Cooperative Hydrology Study (COHYST) Independent Peer Review Findings Final Report

October 15, 2005

The purpose of the Independent Peer Review was to evaluate the credibility of the model reports, the underlying model datasets, and supporting data and information by providing answers to the following questions:

EMU Net Mass Balance Error % of Total Outflow

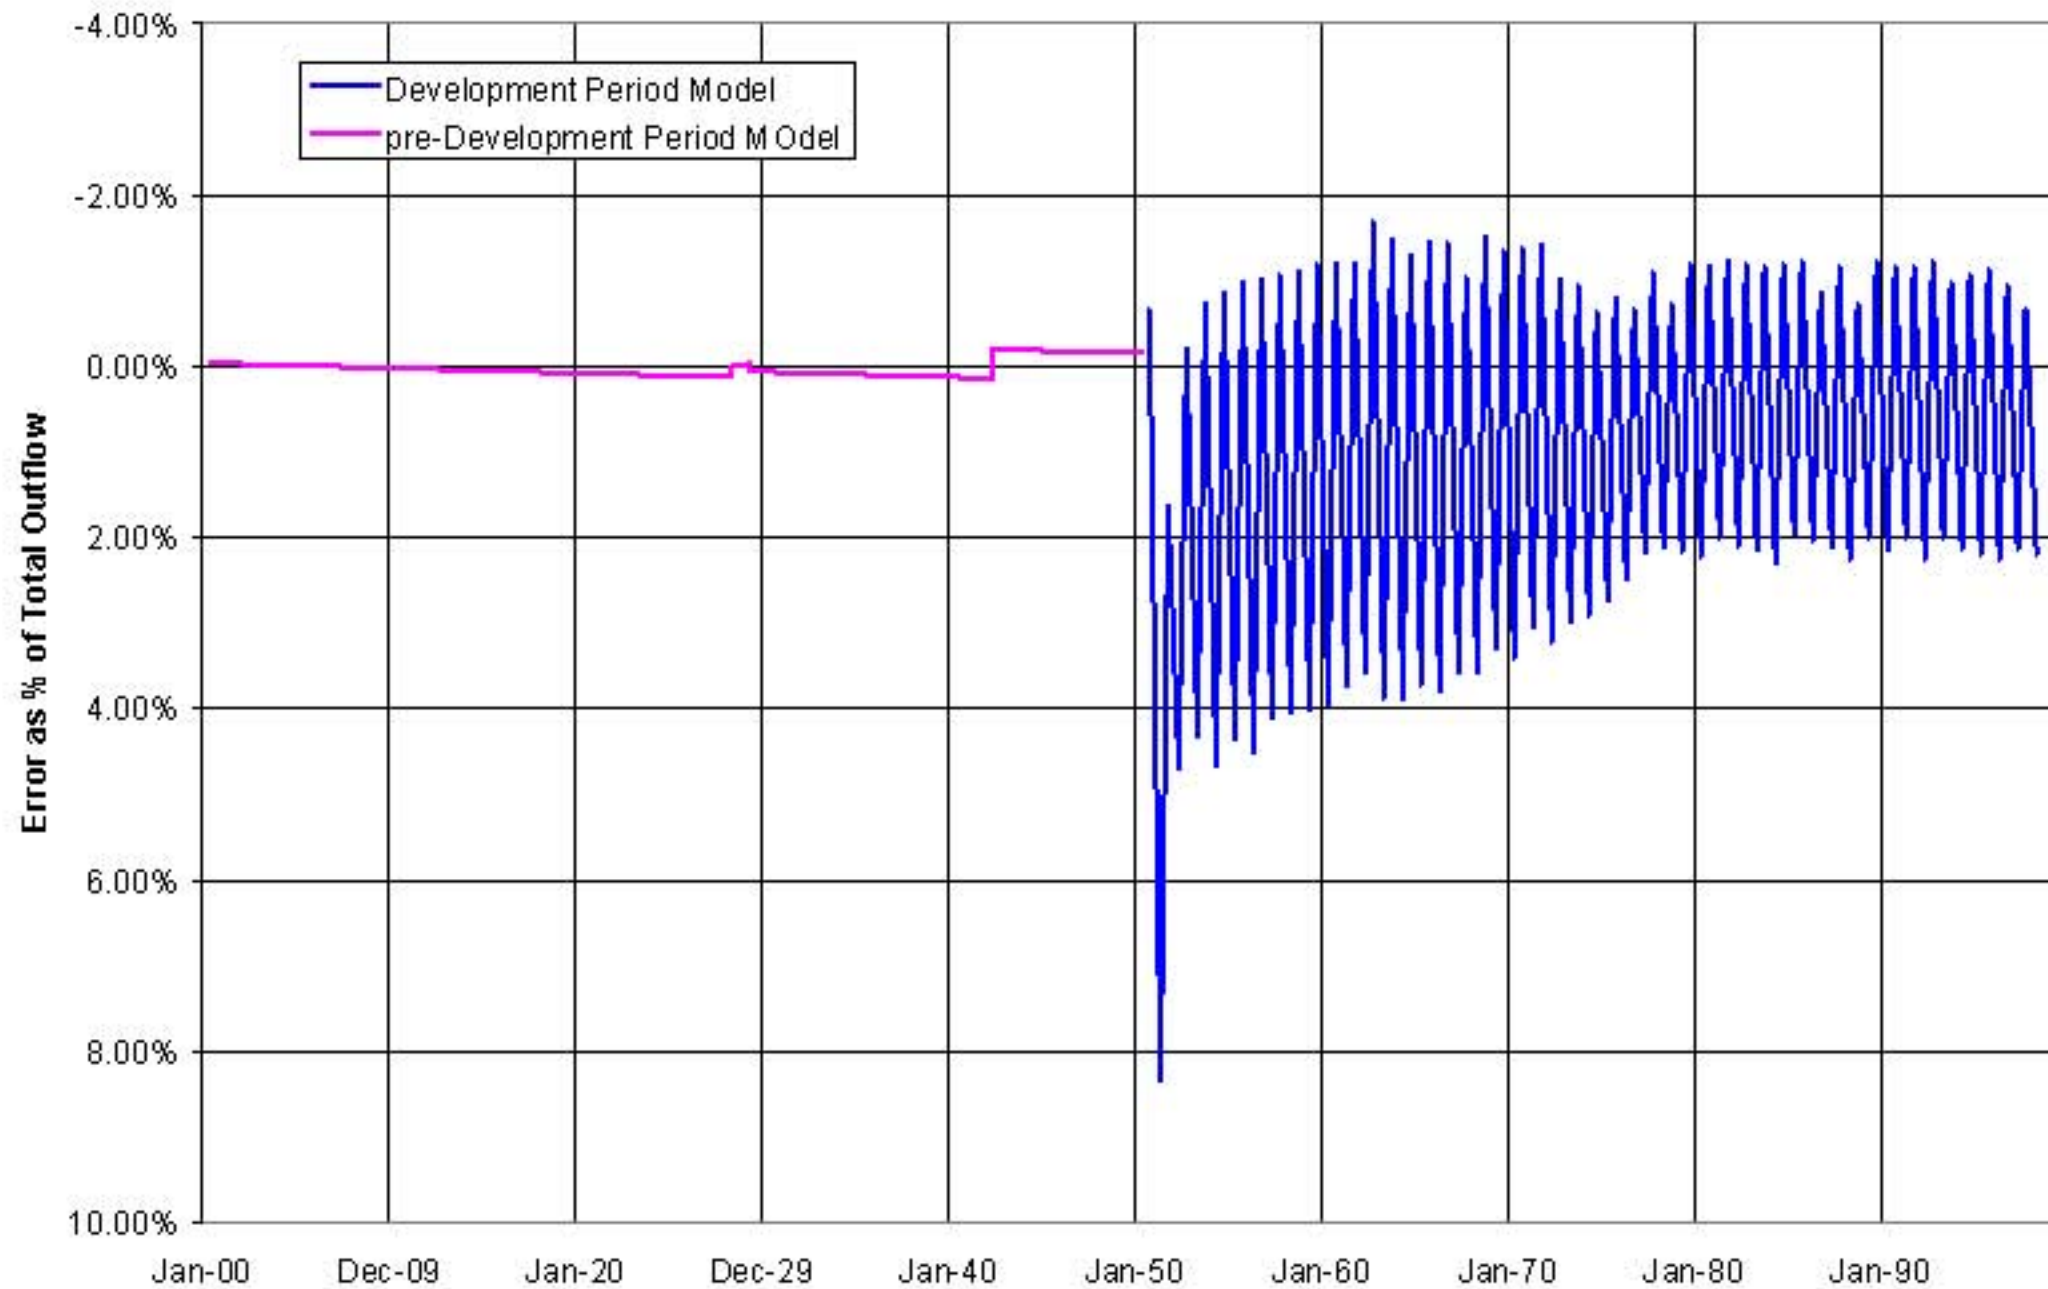
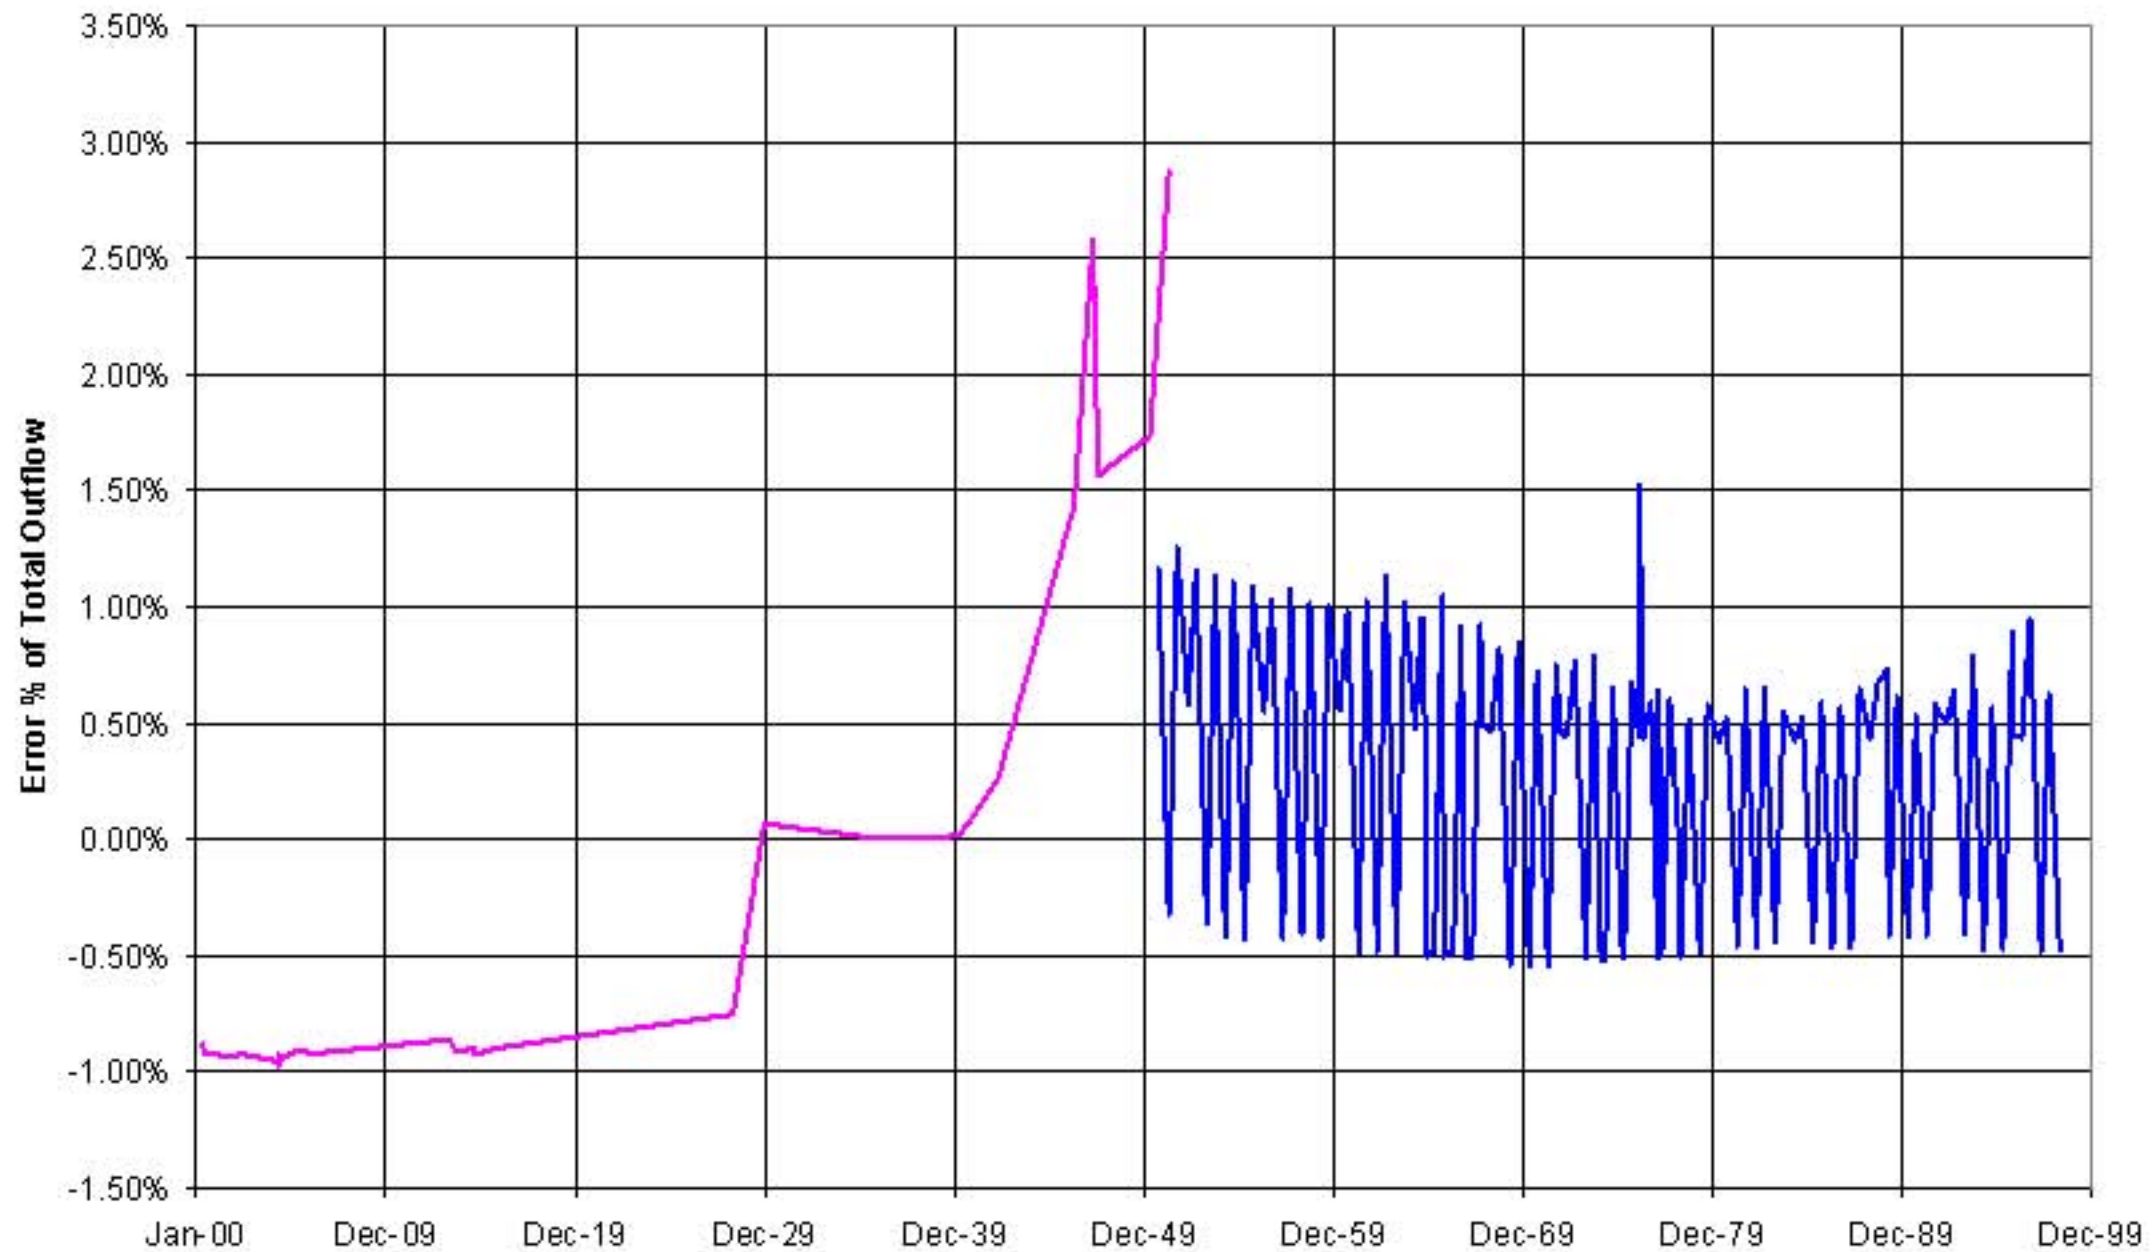
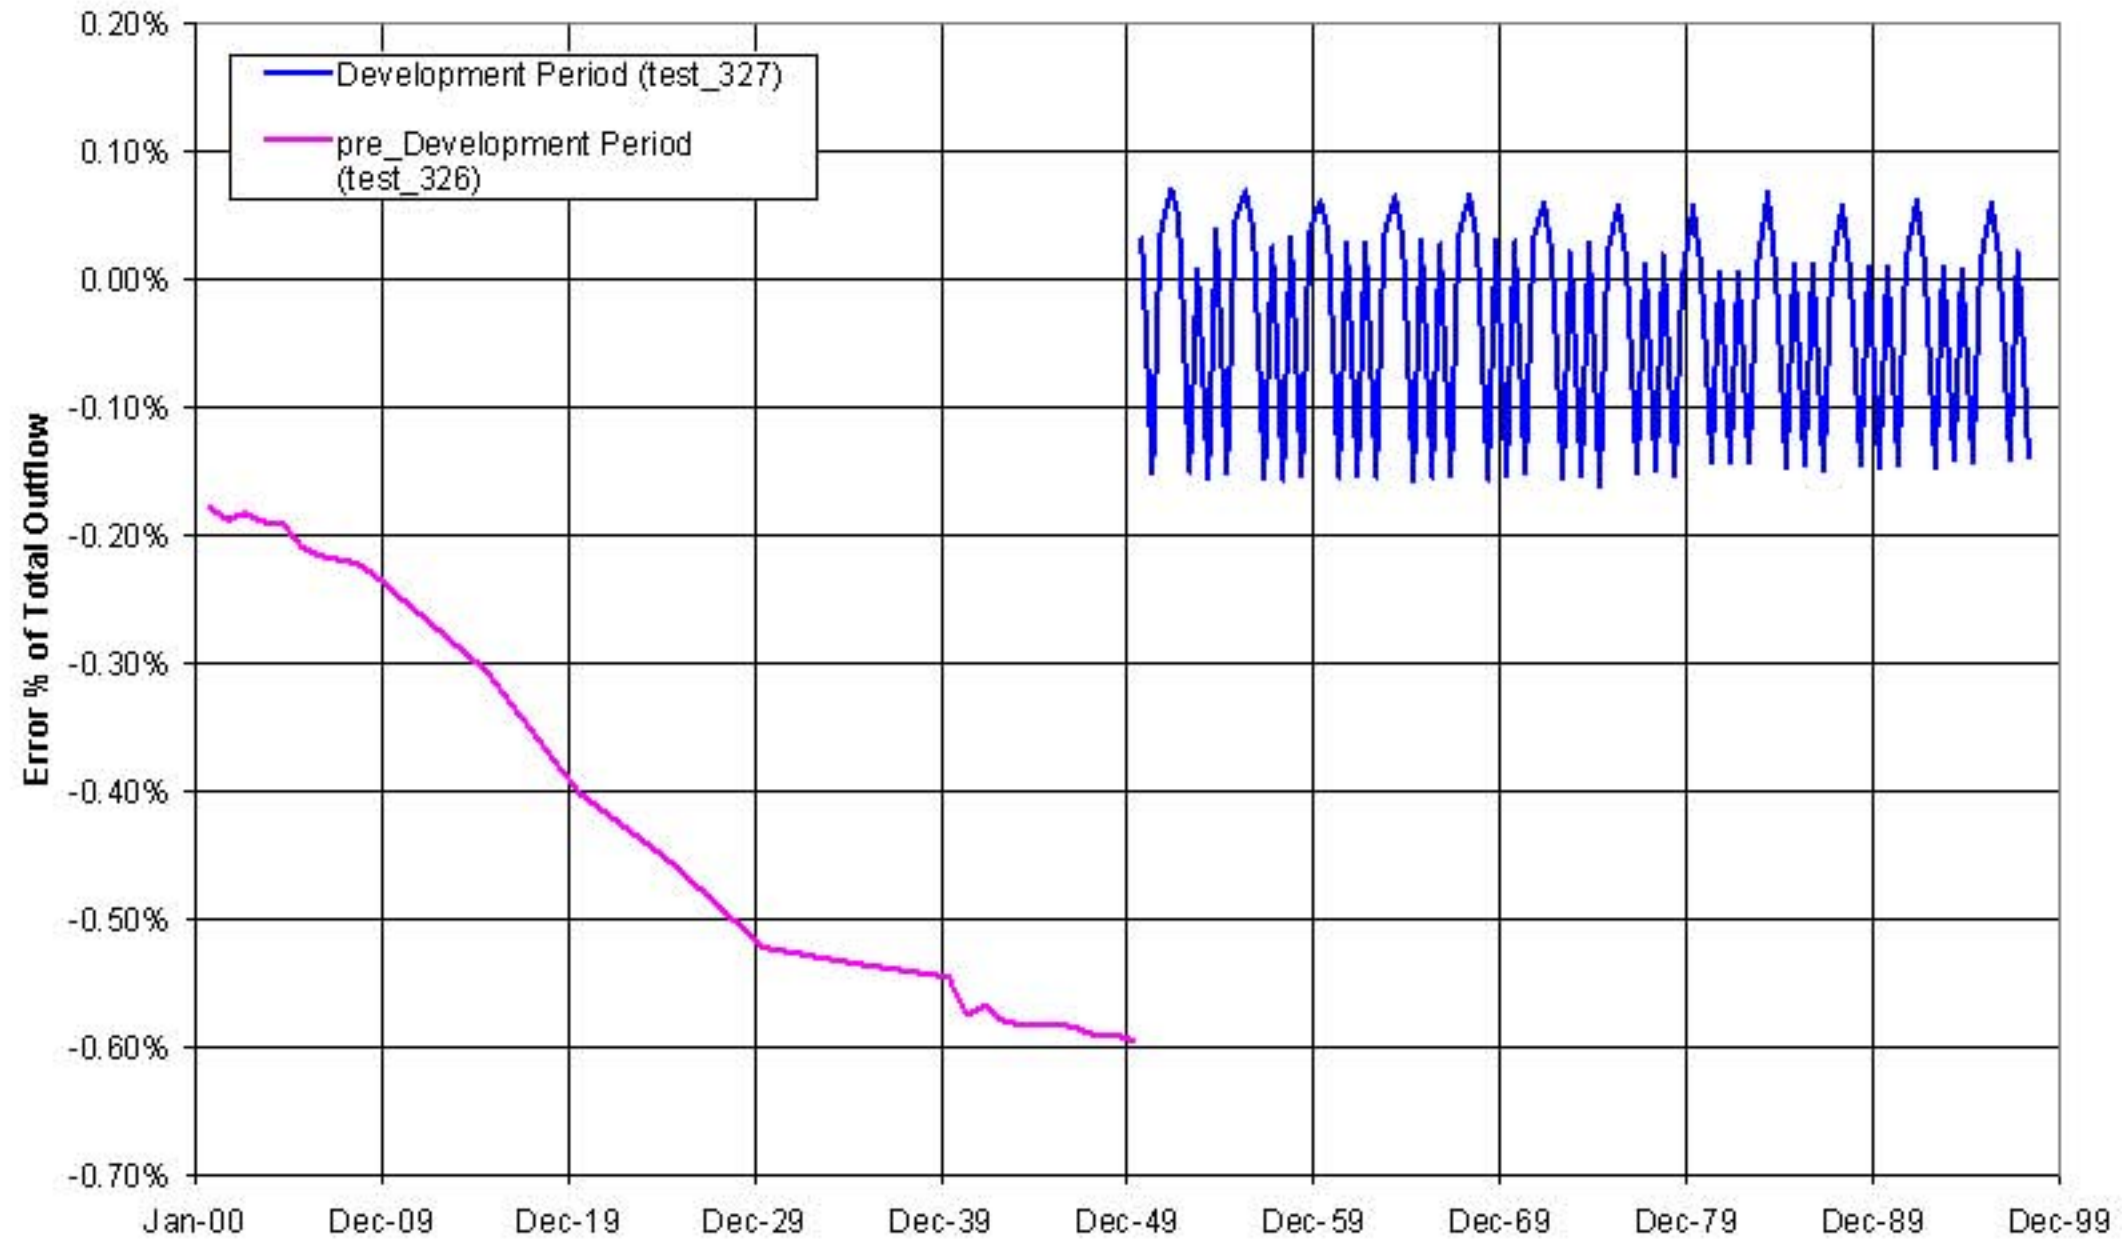
total outflows for each time step as a percentage of total outflows. These charts show that the model precision is well within the 1% to 2% limits considered acceptable by industry standards (Figures 52 -54.). Larger errors than the industry standard were present between 1950 and 1973 for the Eastern Model Unit model, but the errors after 1973 were within the limits. In addition, there is no time trend in the error which would indicate a systematic and persistent error.
